Countries: CANADA, UNITED STATES, MEXICO **Document ID:** IK0700051
Availability: ISIS, FleetISIS **Revision:** 1
Major System: EXHAUST **Created:** 12/20/2012
Current Language: English **Last Modified:** 12/21/2012
Other Languages: NONE **Author:** Charles Sun
Viewed: 224

Title: Rear Exhaust Manifold Leak**Applies To:** MaxxForce® DT, 9 and 10 (2010 M.Y.)

Photo Showing the Revised Manifold

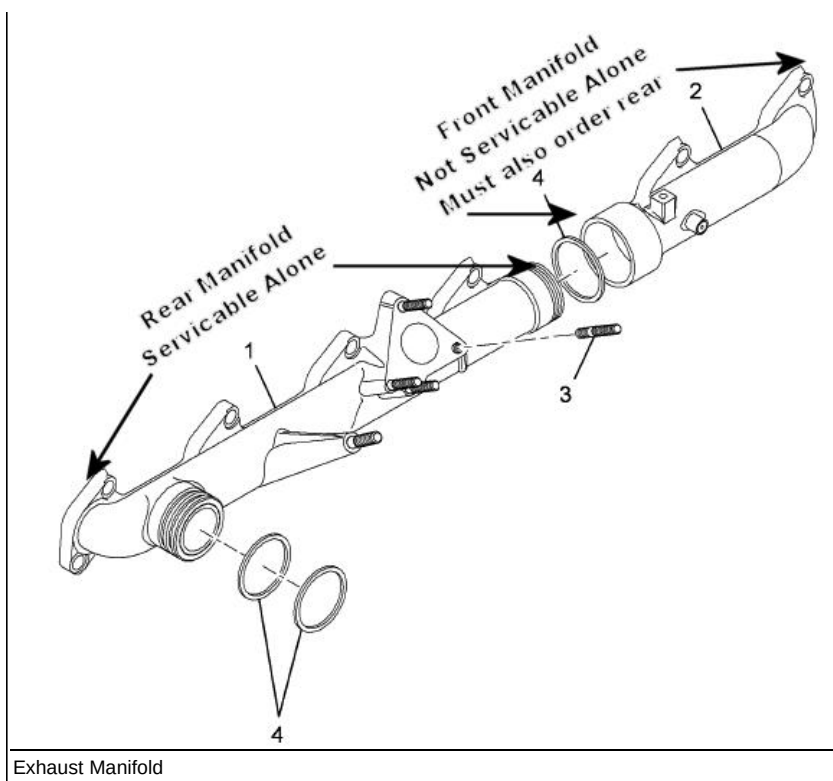
When truck is serviced for rear exhaust manifold leak, check for presence of a square shaped ear at rear of exhaust manifold. Current production exhaust manifolds have been modified to remove ear and existing inventories had these ears machined off.
